Written Representation of Bishopton Villages Action Group (BVAG)

Application by RWE Renewables UK Solar and Storage Limited
Proposed Development Consent for the Byers Gill Solar Project.

PINS ref: EN010139

29th August 2024

Figure 9 - Bishopton Conservation Area

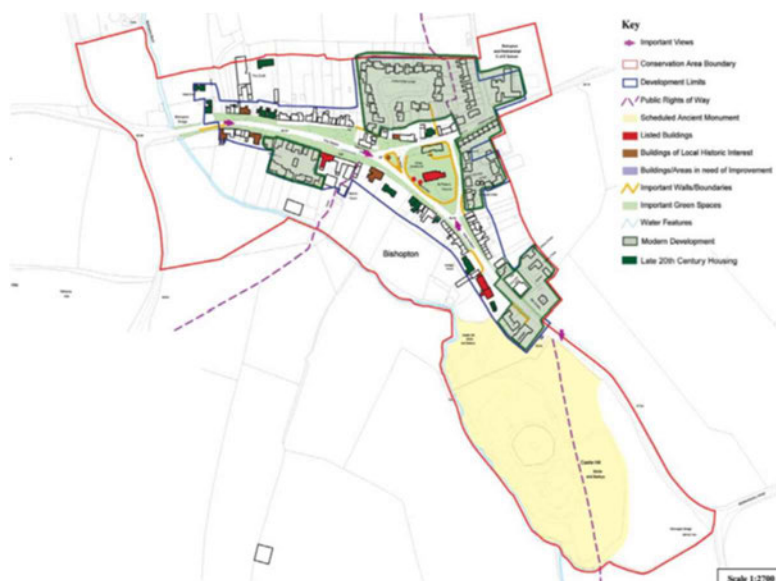
4.10 The Bishopton Conservation Area (CA) will be surrounded by proposed solar PV and other infrastructure, such as fences, CCTV, batteries and invertors. The CA has important key recognised views both within and from outside the village. It is essentially a village set within an rural area.

4.11 Historic England (HE) in their representation in May 2024 (RR-207) states its concern for the Bishopton Conservation Area is specifically how the DCO application relates to the impact on setting of Bishopton Conservation Area. HE conclusions differ from the applicant's conclusions. HE express concern relating to the stopping of footpaths and a change from a rural to an urban experience. They state that

Figure 12 - Geophysical Survey Area 4 - excludes Bishopton Castle

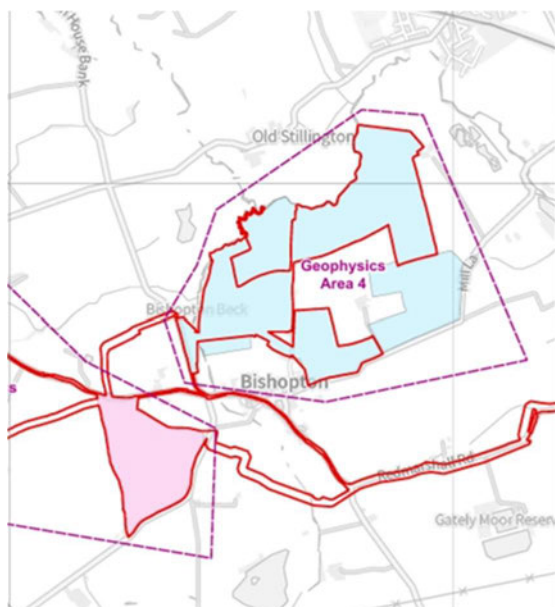
4.31 It is unclear why the Bishopton Motte and Bailey and its surrounds were excluded from the area wide Geophysical survey – especially as this is the highest grade Heritage asset.

4.32 As one of the area's highest heritage assets it would seem important to include the Motte and Bailey and surrounds in the geophysical surveys. The plan above indicates how the proposed cable runs immediately adjacent or even through the Motte and Bailey castle, so there is potential for harm through direct impact should cables be laid around and close to it.

- 4.34 BVAG appreciate that with 30 plus km of potential cables, that geophysical surveys might be disproportionately unnecessary. But in the case of a small section adjacent to the Bishopton Scheduled Monument a short addition to the Area 4 Geophysical Survey would seem justified and proportionate. **BVAG would request an explanation from the applicant and Durham County Council archaeologists if justified and acceptable.**

Figure 13 Trial trenching excludes Panel Areas E and F (APP-148)

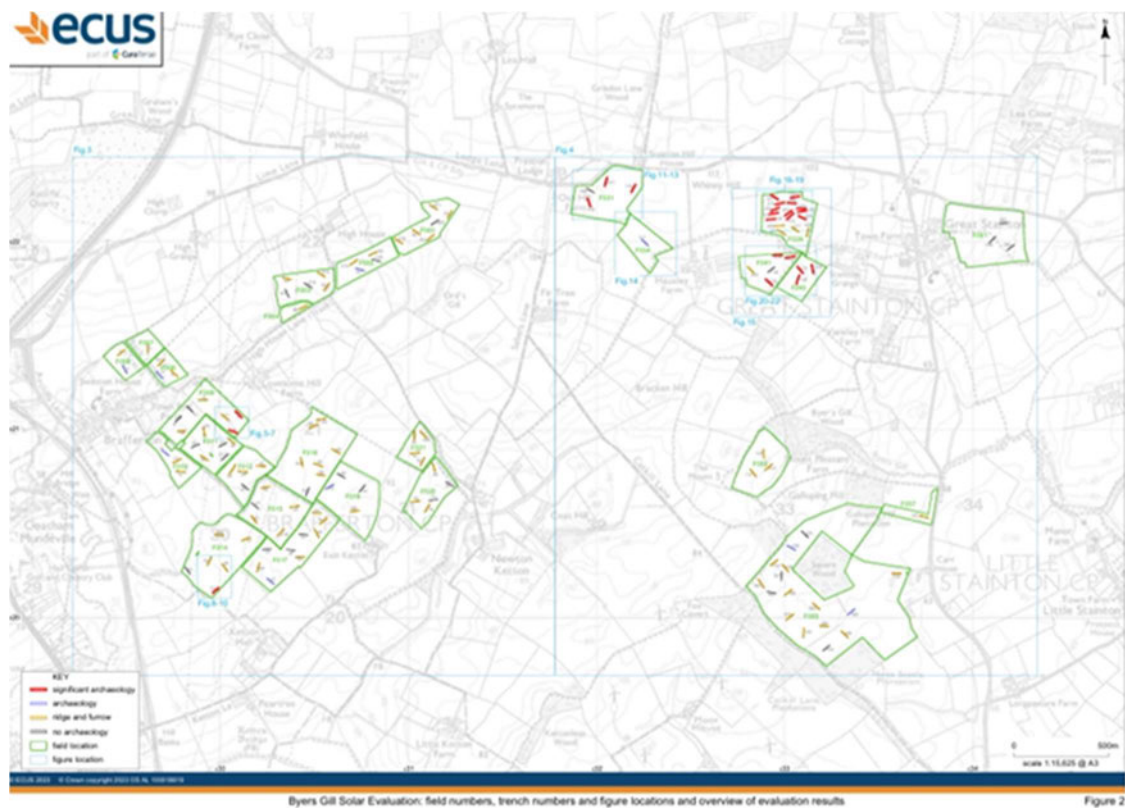
- 4.35 Following the Geophysical Surveys areas were selected for trial trenching. The subsequent trial trenching excluded Panel Areas E and F entirely. It is not clear if this is driven by decisions around the Geophysical survey or if landowner consent and access was an issue due to crops in fields. Again, BVAG would request from the applicant and Durham County Council Archaeologists team if this is justified and acceptable, given Panel Areas E and F provide potentially rich sources of Archaeological finds.

- 4.36 The table below shows the areas selected for Trial Trenching which includes parts of Panel Areas A - D and exclude entirely E to F.

Figure 1 – image sources from Prof Andy Russell (2015) [4] which illustrated the blockage risk due to debris capture that fences within the floodplain may pose.

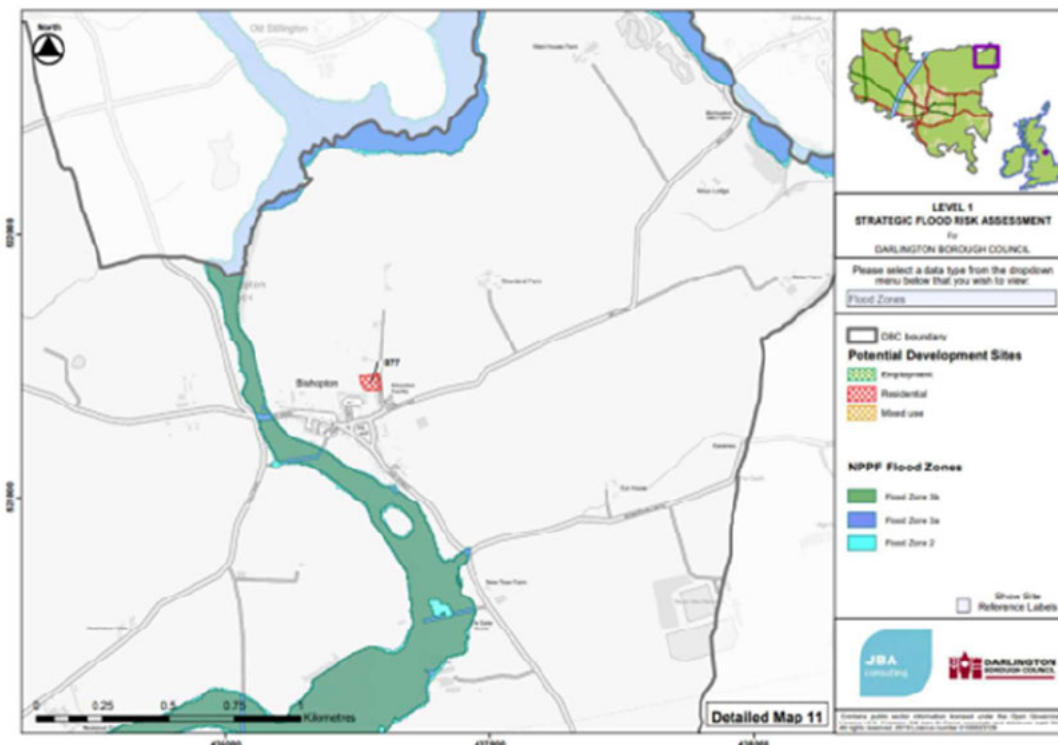
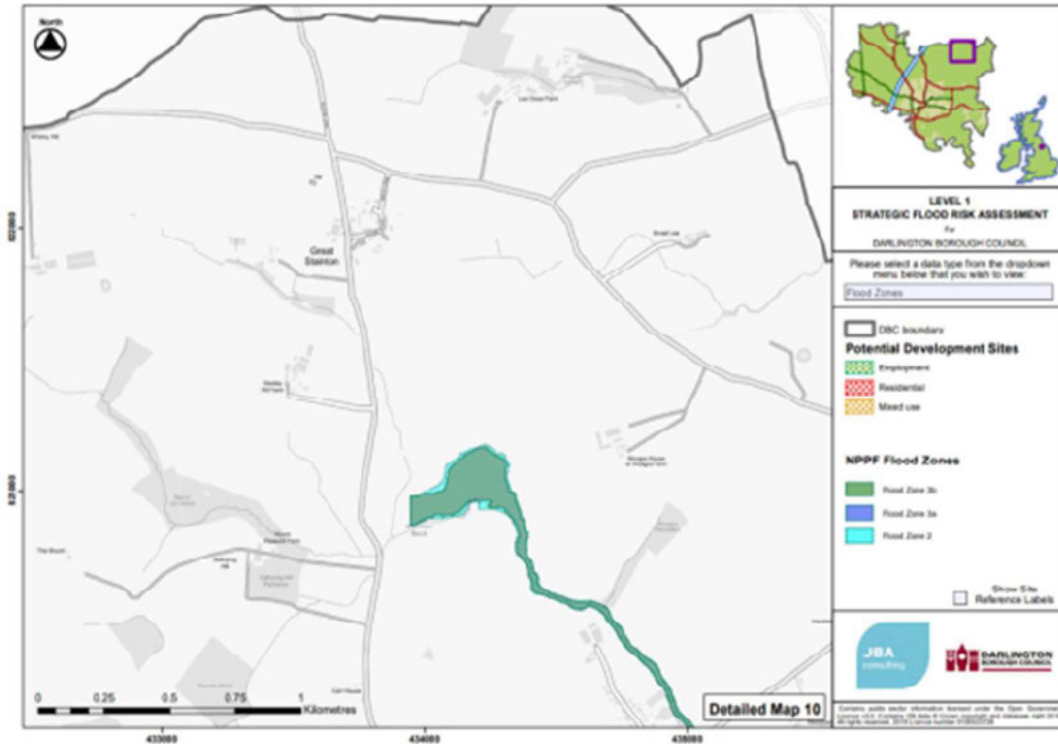
The piles, supporting legs, and boundary fences will all impede water flows across the floodplain in these areas by presenting an obstructing blockage risk. The fencing proposed is 2m high deer fencing outlines in *Chapter 2 The Proposed Development JBM Solar document*. Blockages of structures such as this reduce the flow capacity, trap debris which further reduced flow capacity, and raise water levels. Gov.uk guidance document on Blockage Management Guide SC110005/R1 outlines this information [3]. The image in figure 1 below demonstrated how fences cause significant obstruction to floodplains due to debris blockage.
